**Addendum No.:** 1

**City Project:** 19-33, "Dried Solids Storage Area"

**ADDENDUM NO. 1**

**City of Turlock  
Contract Documents and Construction Specifications  
Project No: 19-33  
Dried Solids Laydown Area**

**PROJECT NUMBER**  
 60563672  
**SHEET TITLE**  
 GRADING PLAN  
**SHEET NUMBER**  
 C-202

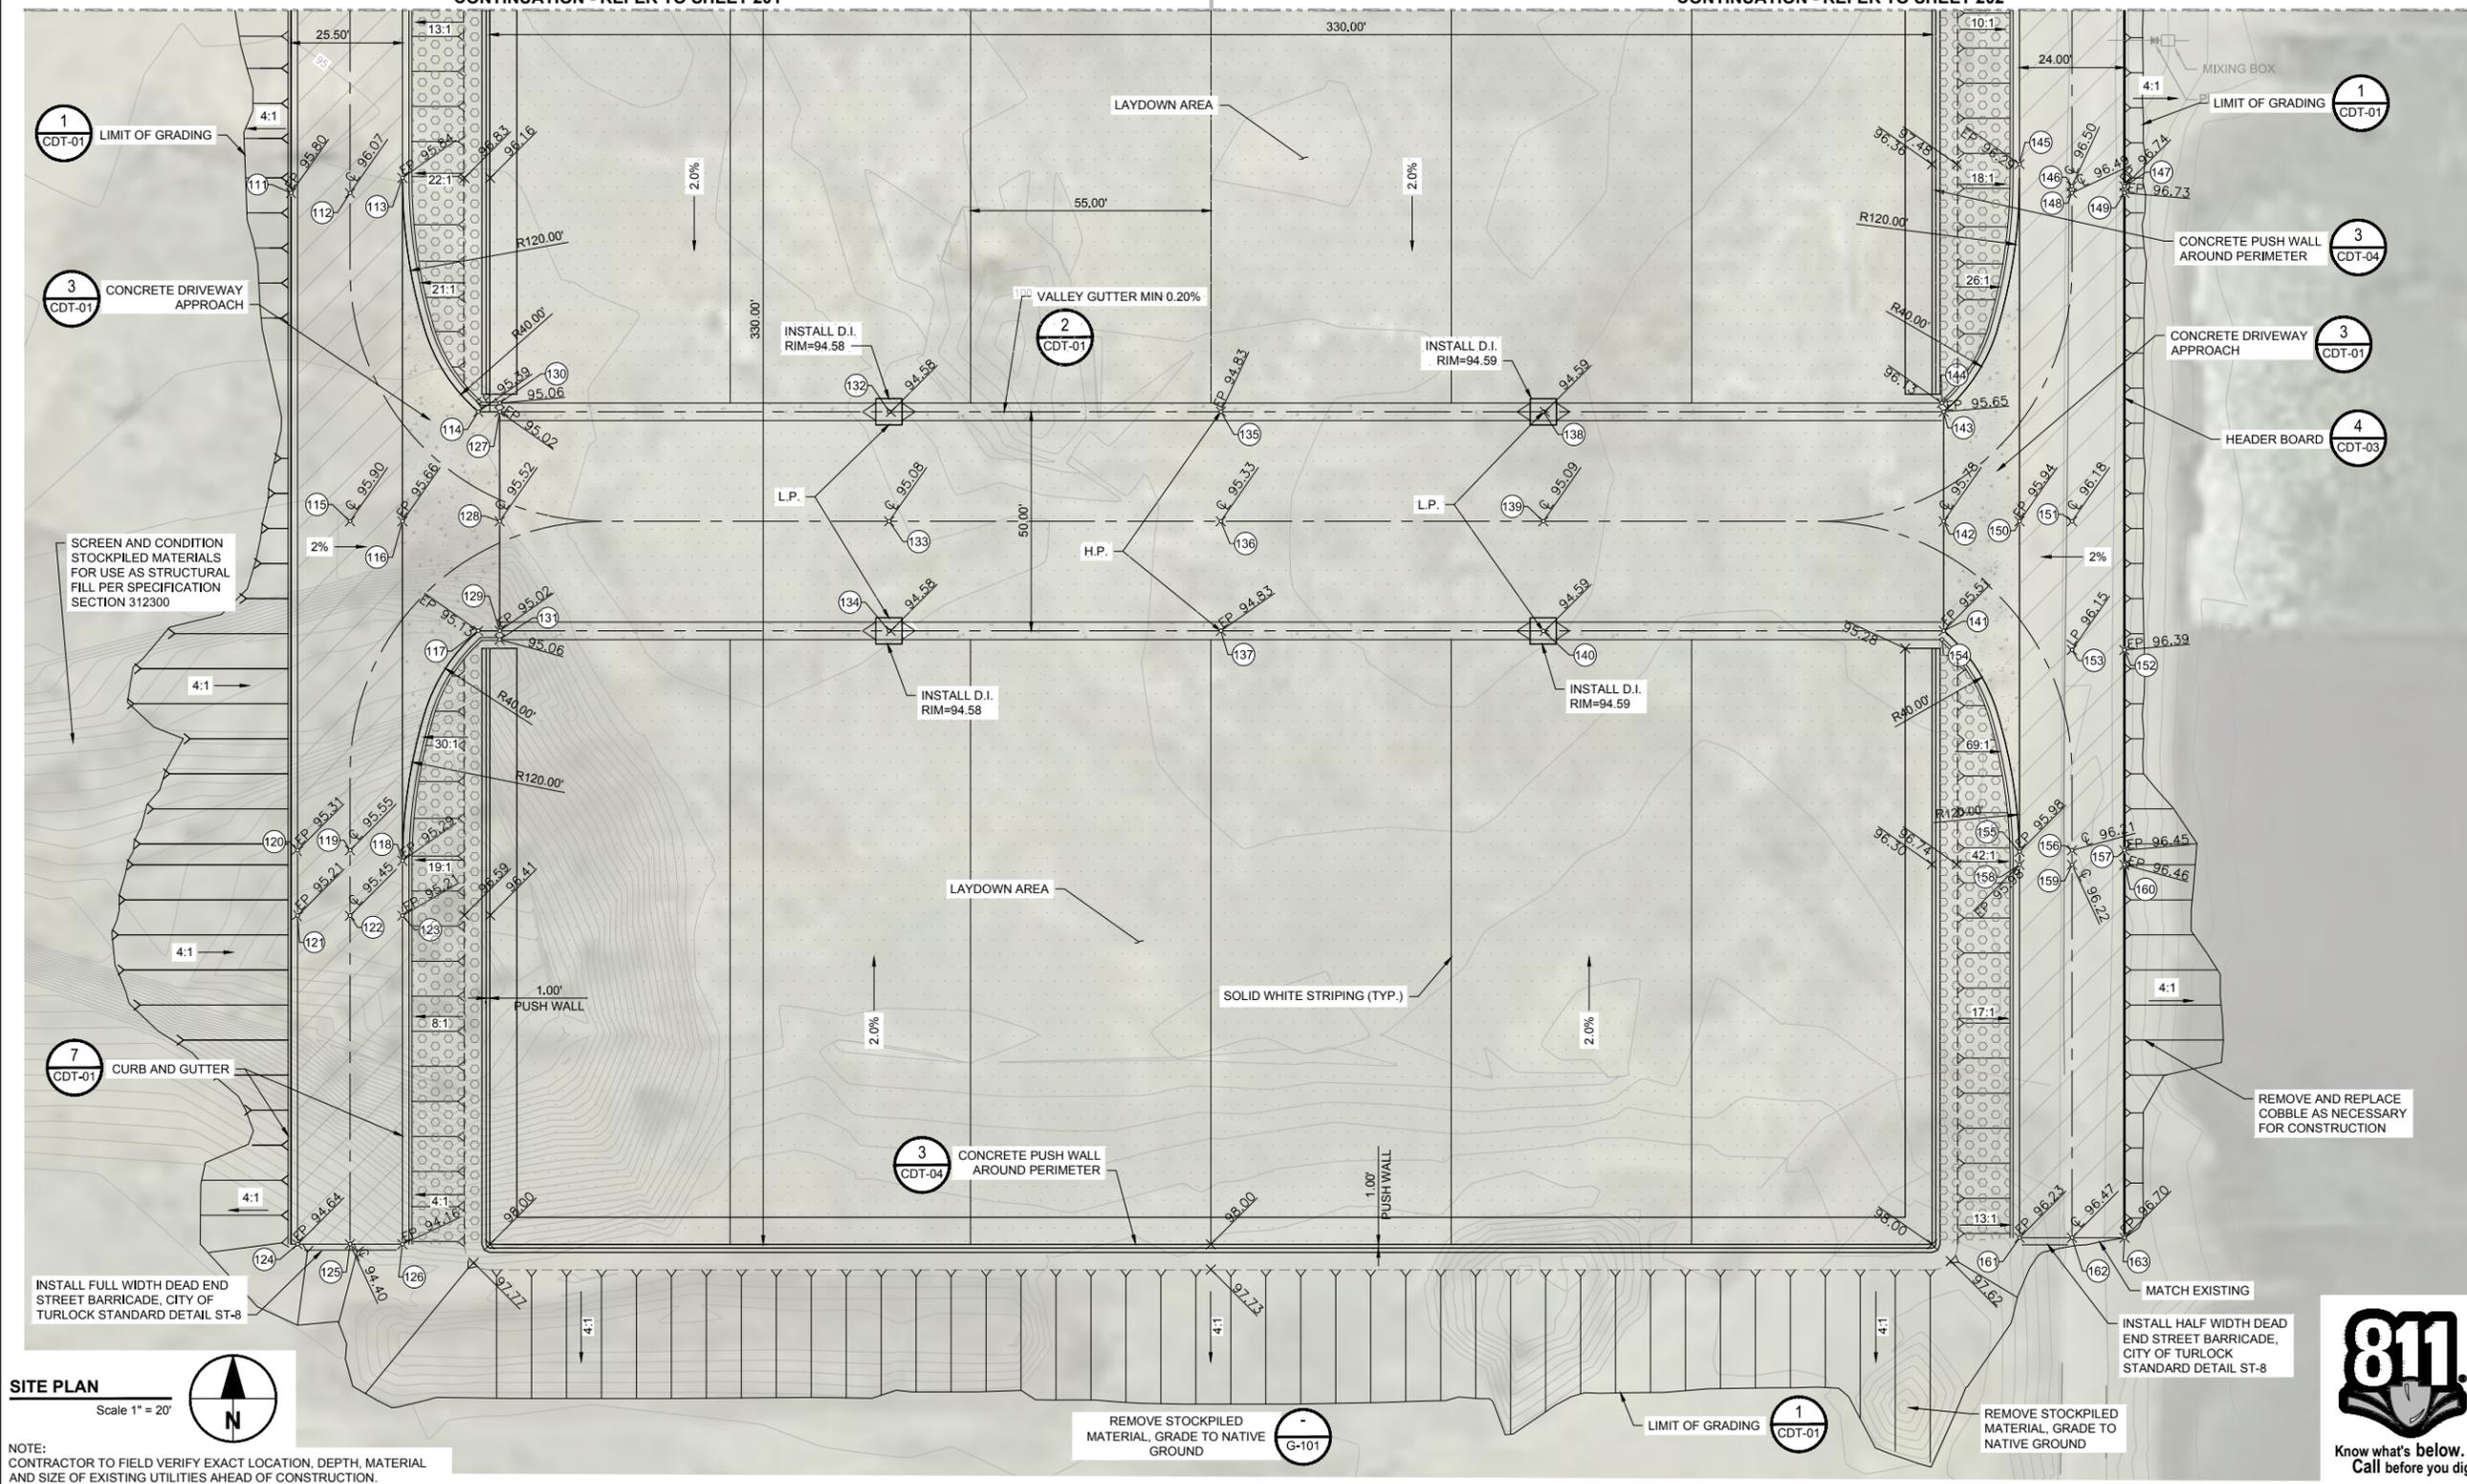
12.	Drawings C-201 through C-205	Linework labeled "Install Header Board 4/C-503" has been adjusted to double thickness to clarify the extent of header board installation required under Bid Item 22.  Construction joint layout in washdown area has been modified to be consistent between sheets.  Gutter has been removed along the north side of the washdown area.  Corrected concrete push wall detail reference to 3/CDT-04  Updated sheet attached.

7. The standard construction joint Detail 4/CDT-04 shows waterstop. Please clarify if the concrete washdown area requires water stop.

8. Drawing C-205 shows lines without designation throughout the washdown area. These would seem to indicate construction joint or control joint layout, but they do not match the call out on Drawing C-202. Please clarify.

Answer: Construction joints in the washdown area called out on C-202 require waterstop as shown in detail 4/CDT-04

Answer: See revised Sheets C-201 and 202 and Sheet C-205.

**PROJECT NUMBER**  
 60563672  
**SHEET TITLE**  
 VACTOR STRUCTURE LAYOUT  
**SHEET NUMBER**  
 C-205

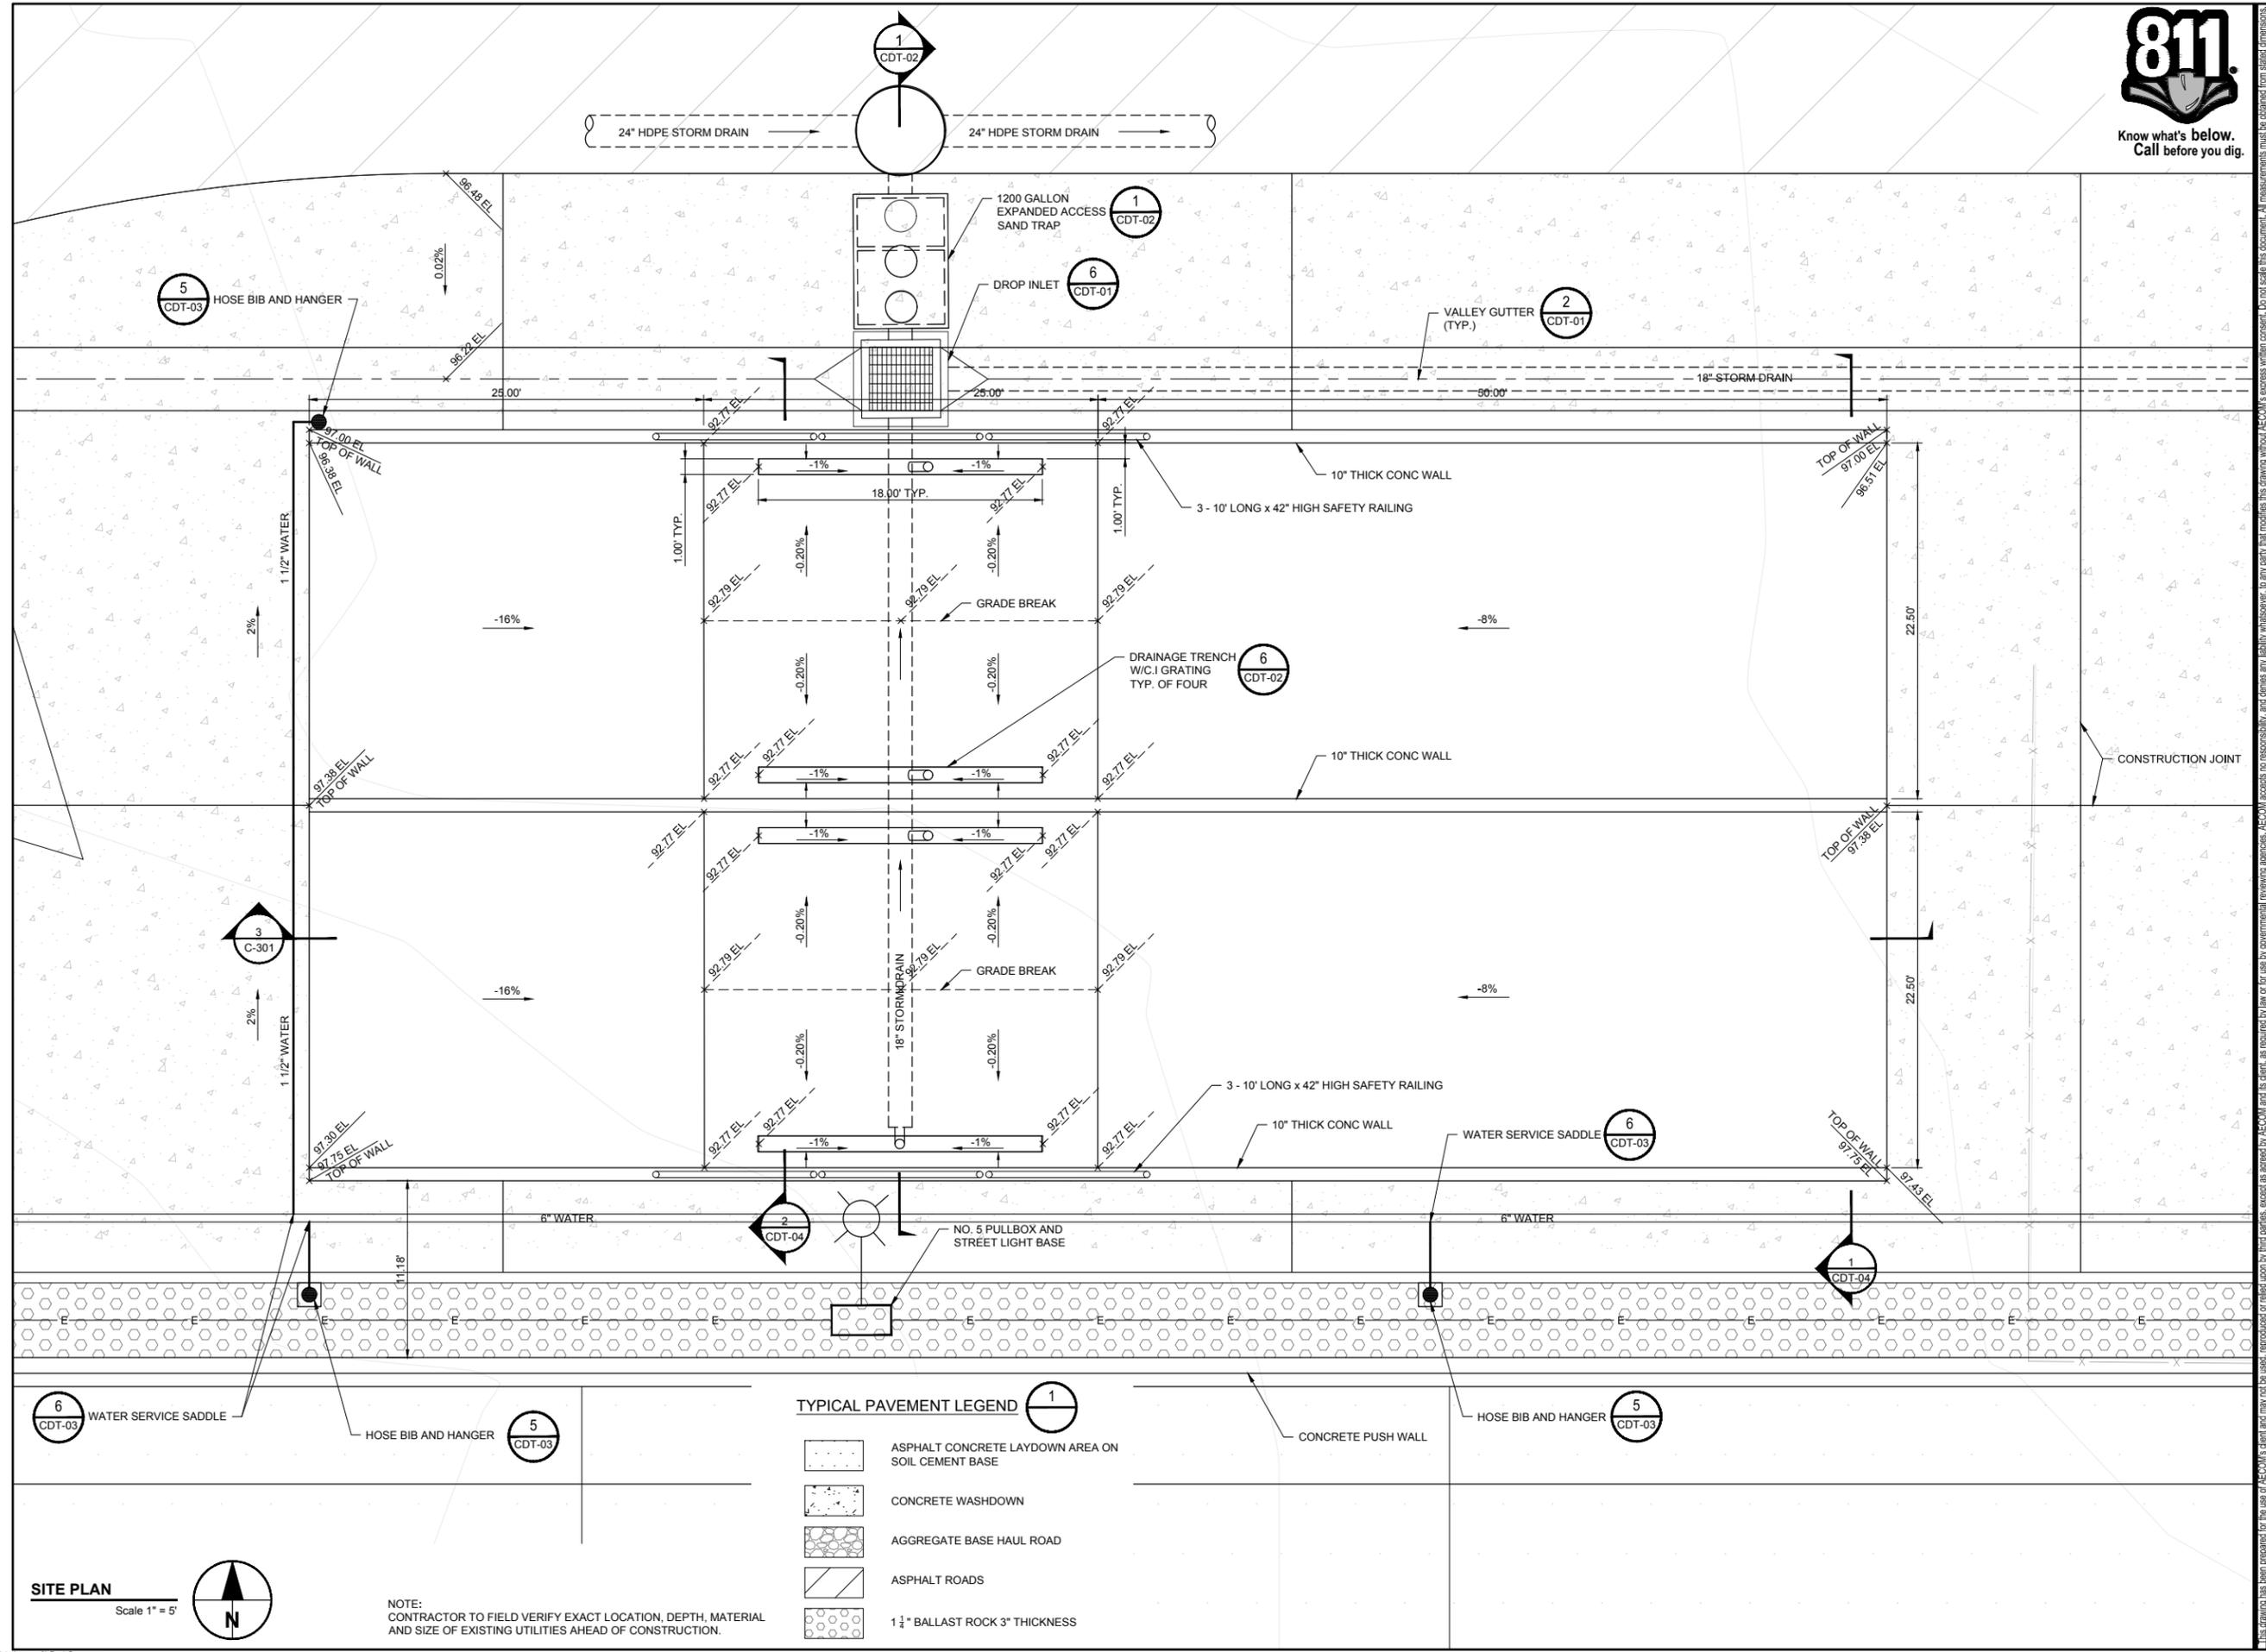
13. Drawings C-201, C-202 and C-205 indicate curb and gutter between the ballast rock north of the laydown area push wall and the concrete washdown. The concrete washdown slopes to the north away from the curb and gutter. Please clarify configuration of the curb and gutter at this location.

Answer: Sheets C-201, C-202 and C-205 have been revised to omit the gutter in this section.
